November 24, 2025

OHIO RIVER TUNNEL

ADDENDUM No. 7

- Revised O06A-CI-807 (Sheet 616 of 770) (1 page)
- Revised O06A-CI-808 (Sheet 617 of 770) (1 page)
- Revised ORT-MD-032 (Sheet 679 of 770) (1 page)

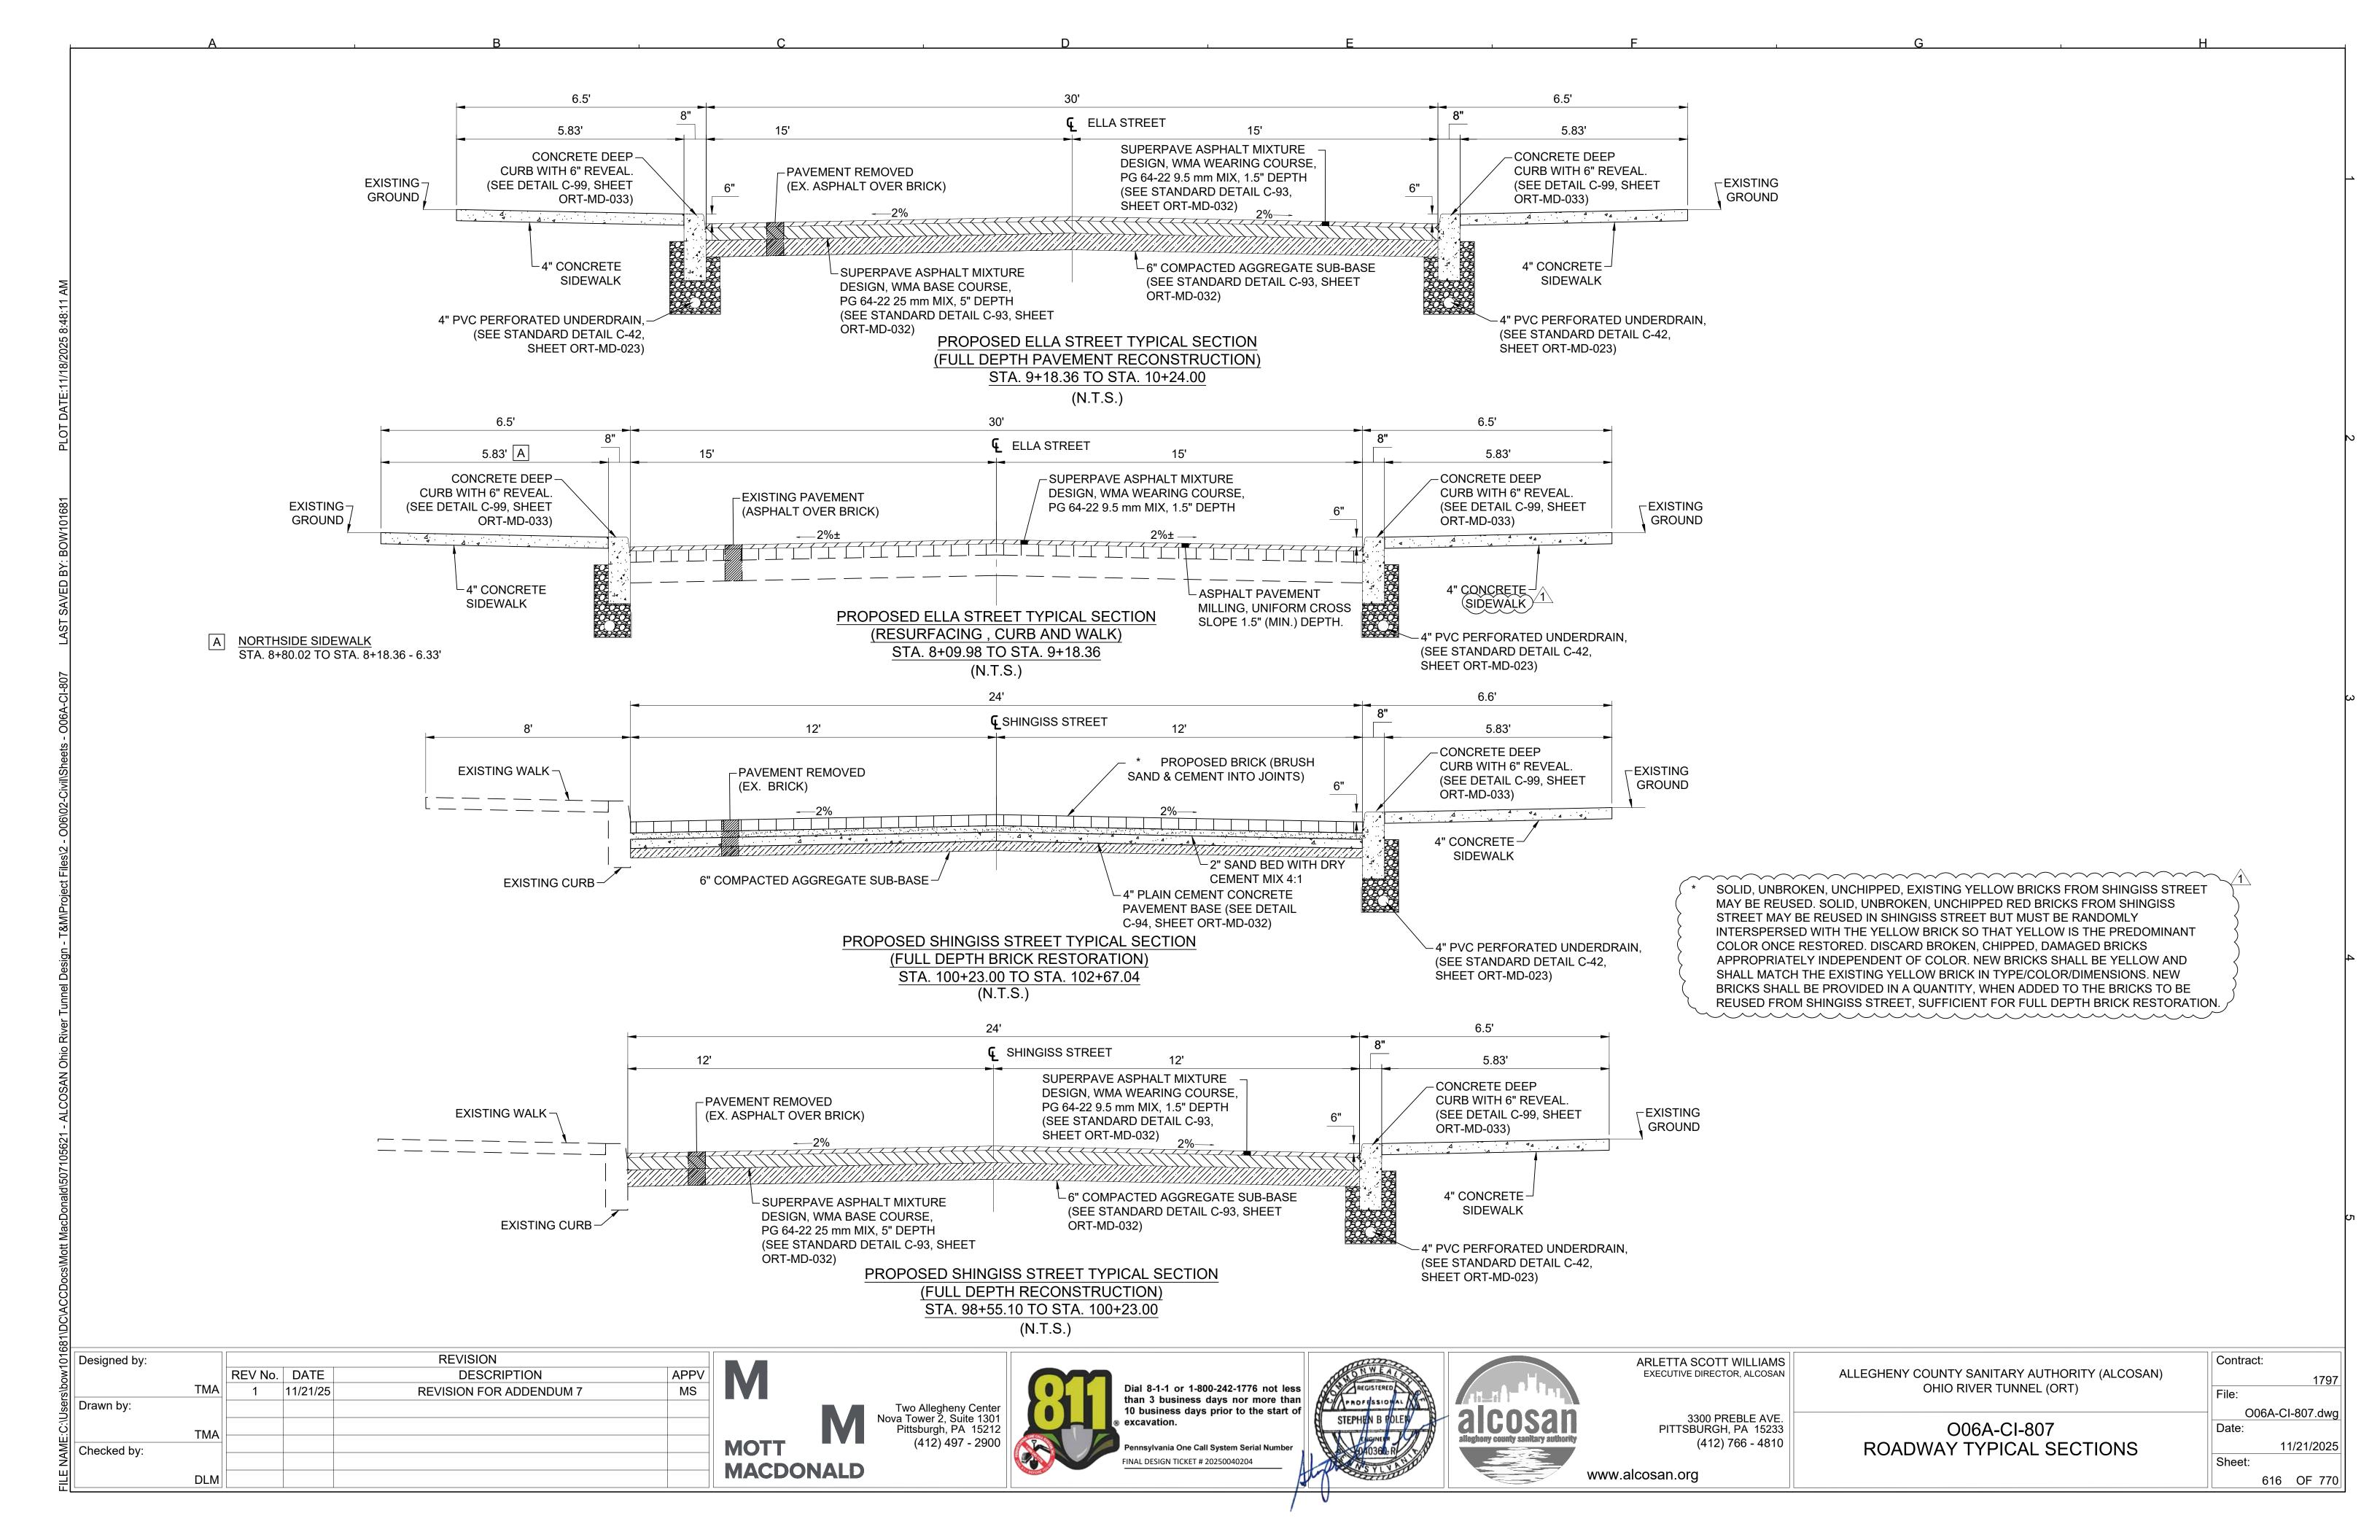
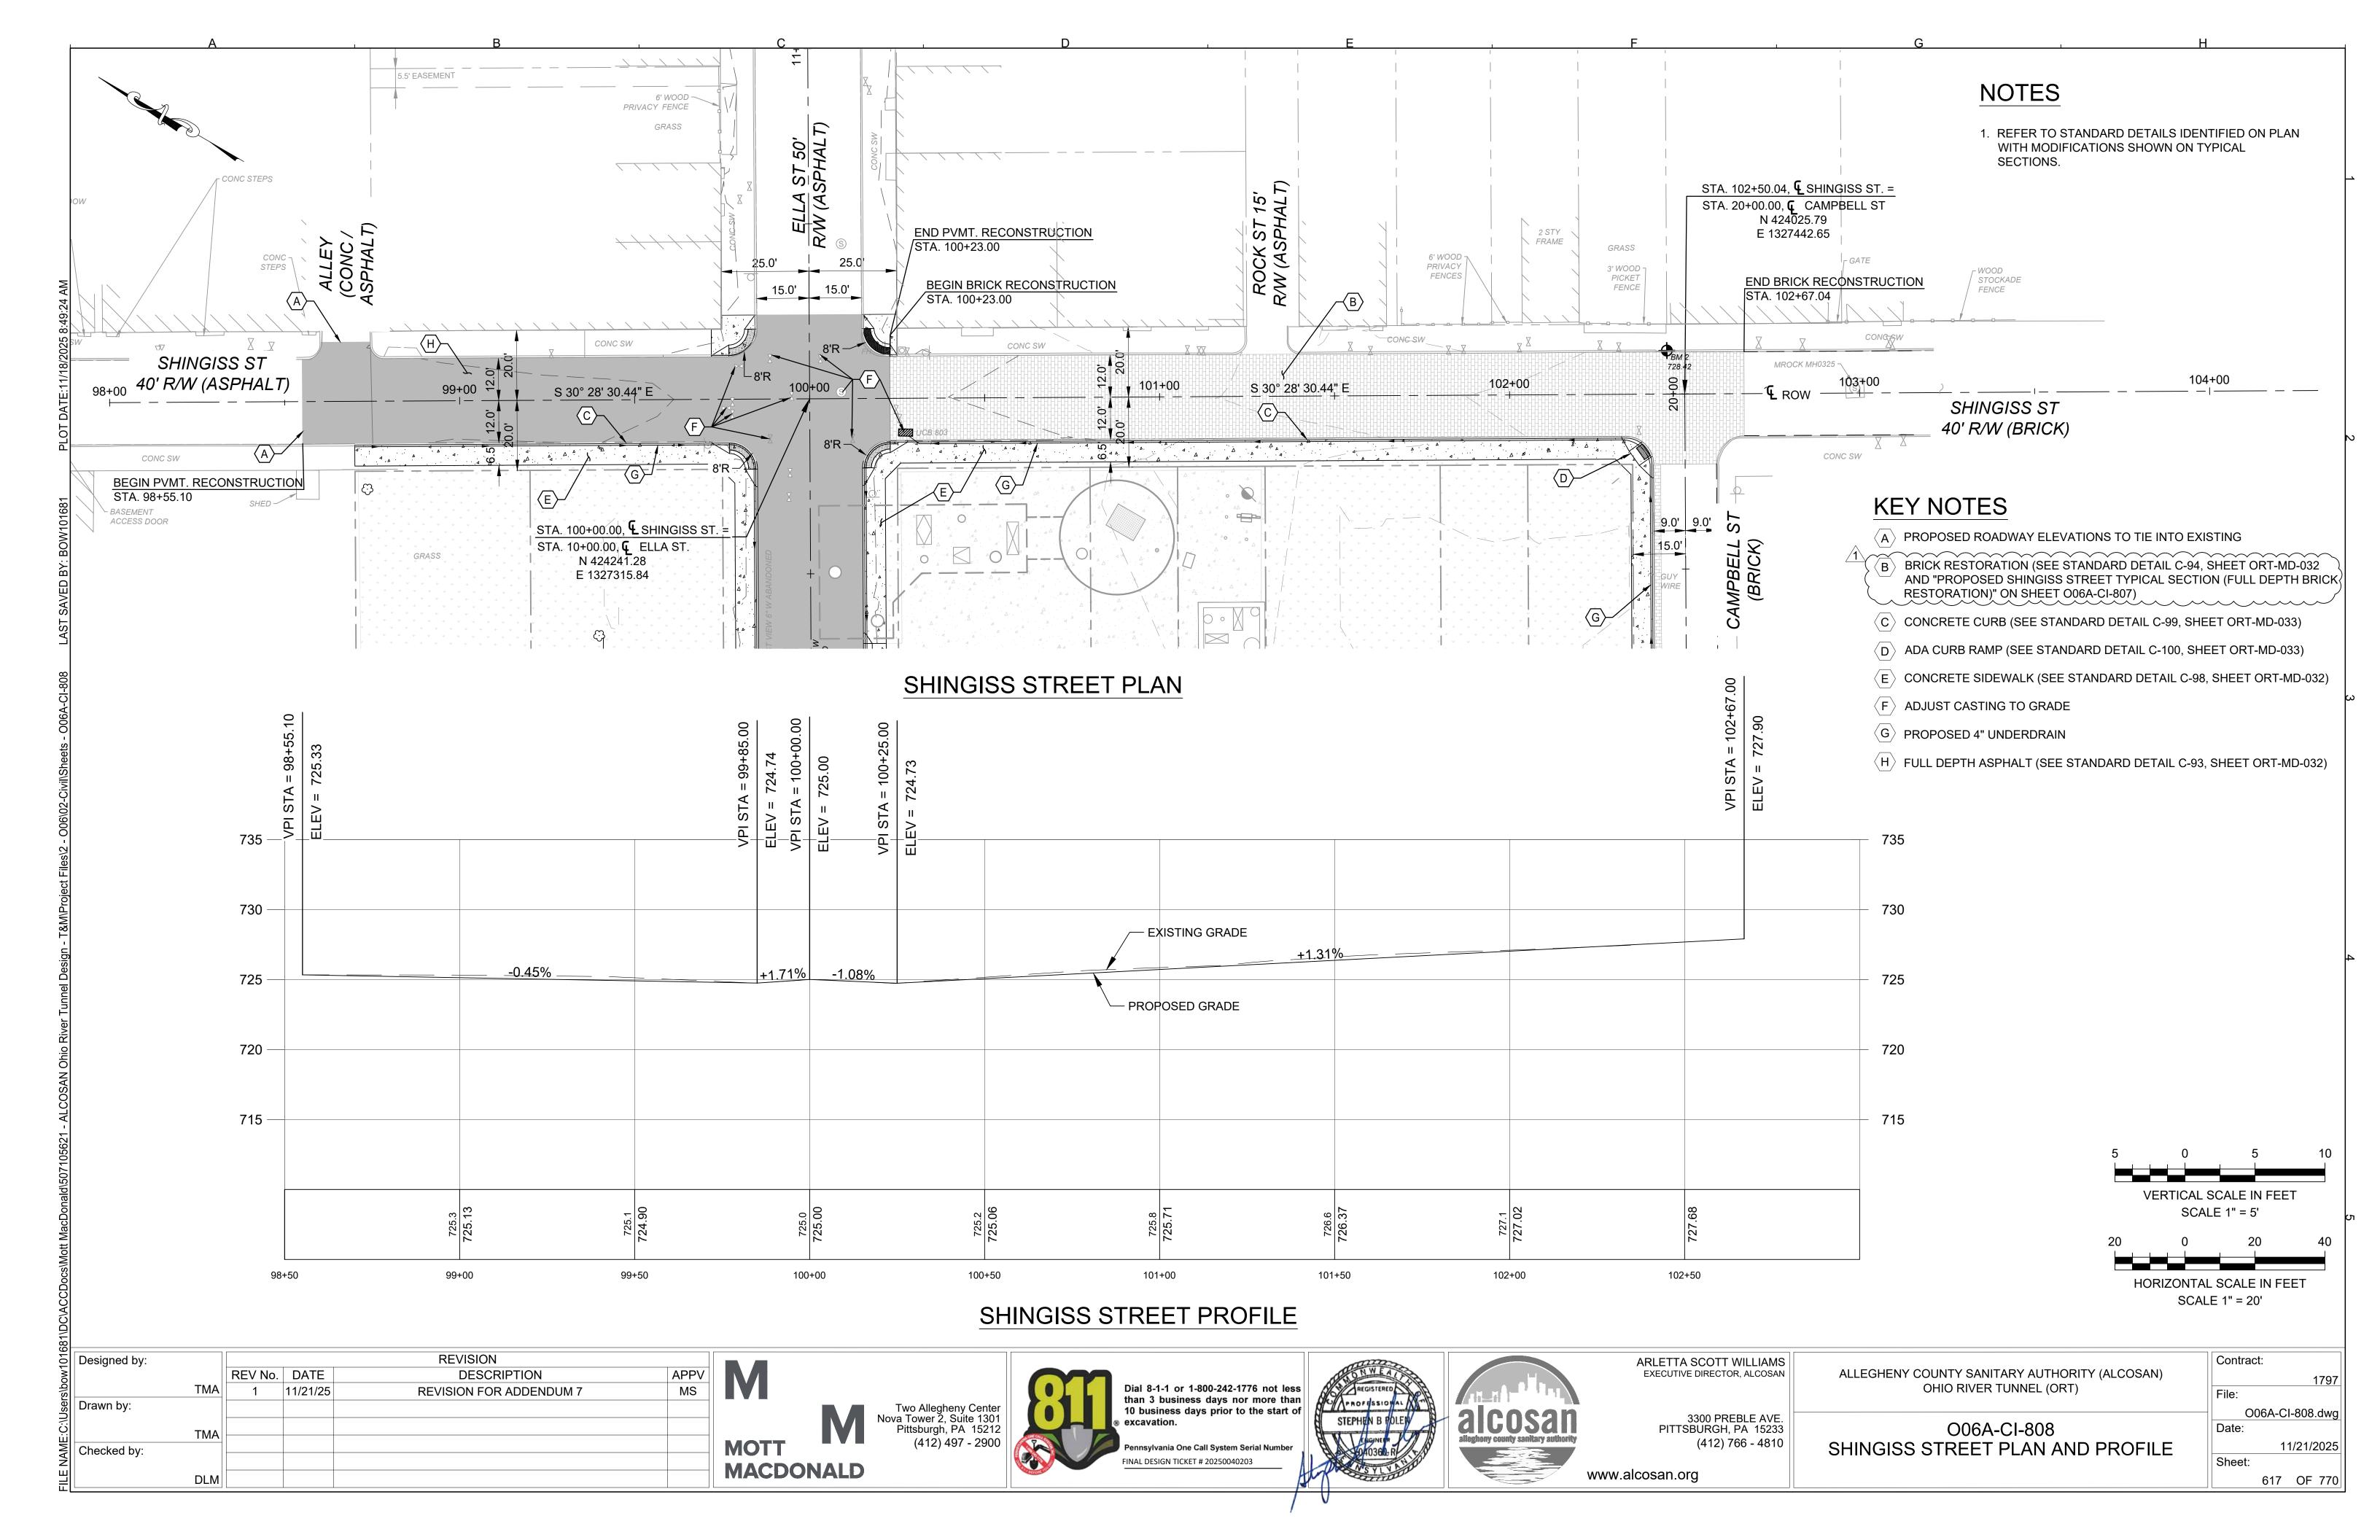
- Q22 Brick Restoration Key Note B on drawing sheet O06A-CI-808 references Detail C-94 on Sheet ORT-MD-032 for Brick Restoration. Detail C-94 is for removing existing brick, cleaning it, and reinstalling the old brick. Does Alcosan want the Contractor to clean and reuse the old brick or replace it with new brick?

- Solid, unbroken, unchipped, existing yellow bricks from Shingiss Street may be reused. Solid, unbroken, unchipped, red bricks from Shingiss Street may be reused in Shingiss Street but must be randomly interspersed with the yellow brick so that yellow is the predominant color once restored. Discard broken, chipped, damaged bricks appropriately independent of color. New bricks shall be yellow and shall match the existing yellow brick in type/color/dimensions. New bricks shall be provided in a quantity, when added to the bricks to be reused from Shingiss Street, sufficient for full depth brick restoration. See Section B, Item 4 CHANGES TO CONTRACT DOCUMENTS for REVISED O06A-CI-807, REVISED O06A-CI-808, and REVISED ORT-MD-032.

- 4. APPENDIX B CONRACT DRAWINGS
 - a) DELETE O06A-CI-807 (Sheet 616 of 770) and ADD REVISED O06A-CI-807 (Sheet 616 of 770) which is Attachment D to this Addendum.

- b) DELETE O06A-CI-808 (Sheet 617 of 770) and ADD REVISED O06A-CI-808 (Sheet 617 of 770) which is Attachment D to this Addendum.
 - c) DELETE ORT-MD-032 (Sheet 679 of 770) and ADD REVISED ORT-MD-032 (Sheet 679 of 770) which is Attachment D to this Addendum.
